LEEDY ADDITION

RE: S/D 99-26 -- Final Plat of LEEDY ADDITION

At the regular meeting of the Subdivision Committee of the Metropolitan Area Planning Commission on Thursday, April 8, 1999, the above captioned plat was considered. The action of the Committee was to approve the final plat subject to:

CASE NUMBER: S/D 99-26 - LEEDY ADDITION

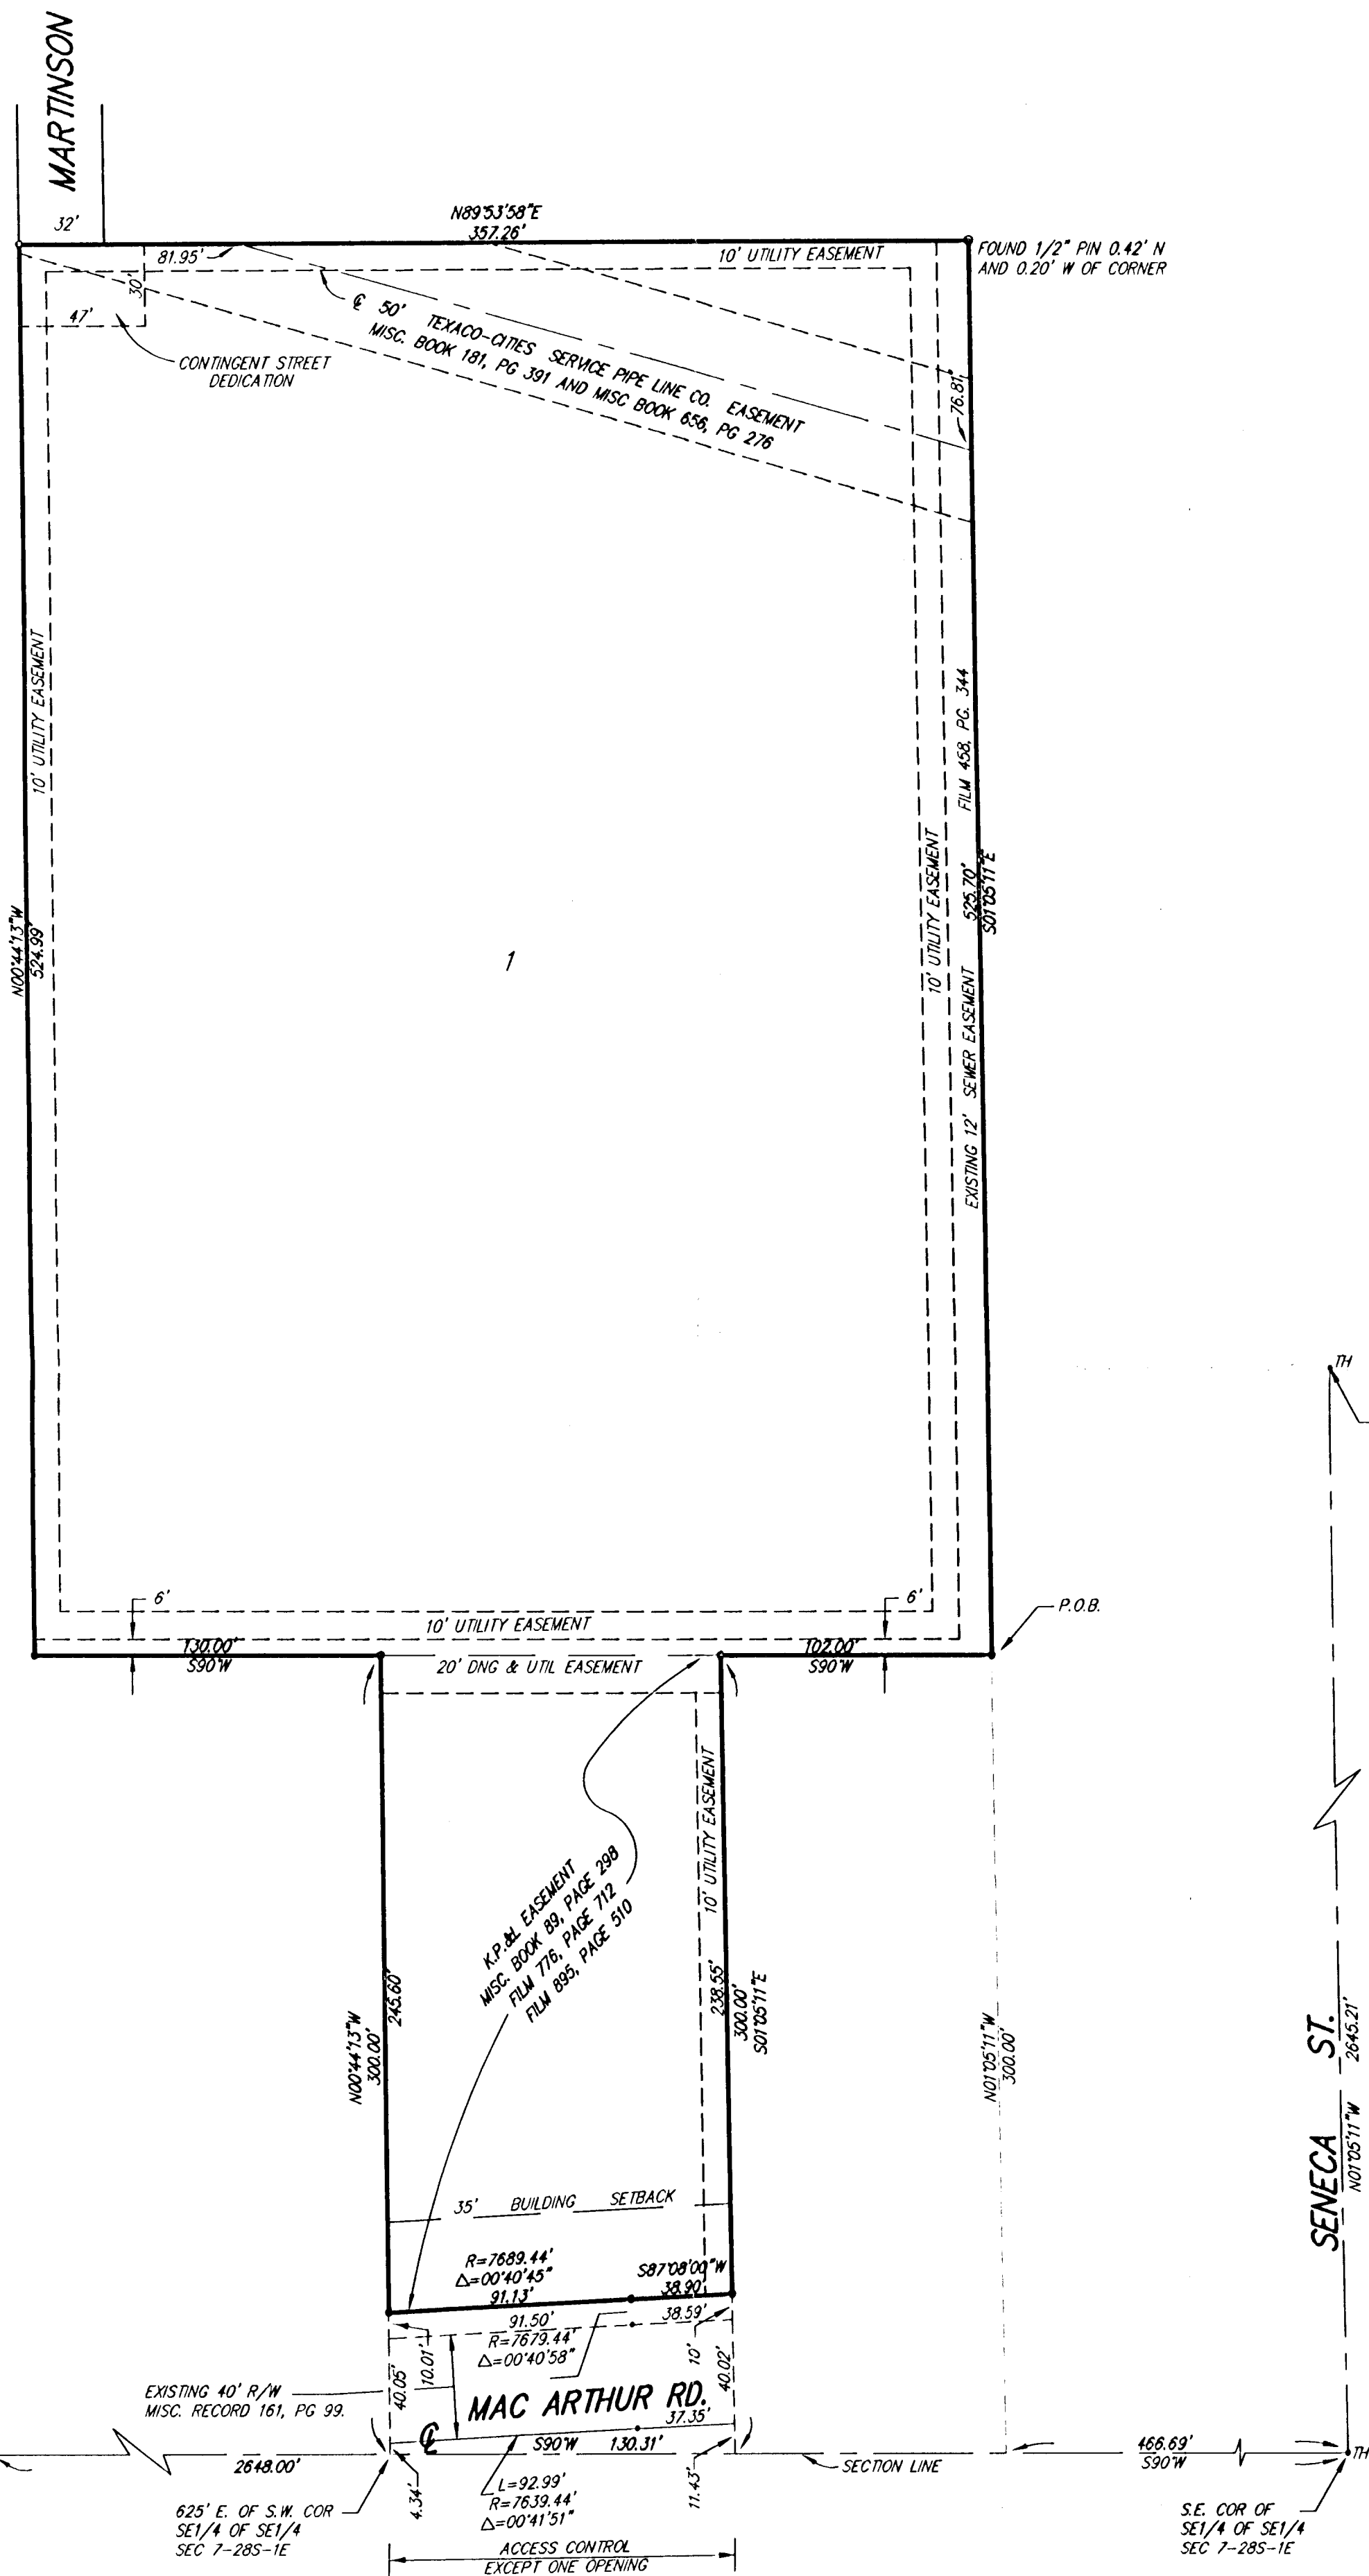
- F. The plat's text shall include language that a drainage plan has been developed for the plat and that all drainage easements, rights-of-way, or reserves shall remain at established grades or as modified with the approval of the applicable City or County Engineer, and unobstructed to allow for the conveyance of stormwater.

- G. The lot exceeds the maximum lot width to lot depth ratio of 3 to 1 for commercial lots, and a modification will need to be approved.

- J. The applicant's agent shall determine any setback requirements for the pipelines by researching the text of the pipeline agreements. If a setback from the pipeline easements is provided for in the pipeline easement agreements, it shall be indicated on the face of the plat and further noted that the setback is a building setback line for the Texaco-Cities Service Company pipeline.

- S. The representatives from the utility companies should be prepared to comment on the need for any additional utility easements to be platted on this property. **Southwestern Bell has requested additional easements.**

U. *A vacation request shall be submitted for Martinson adjoining the plat to the north. In the alternative, a paving guarantee shall be submitted for a turnaround.*
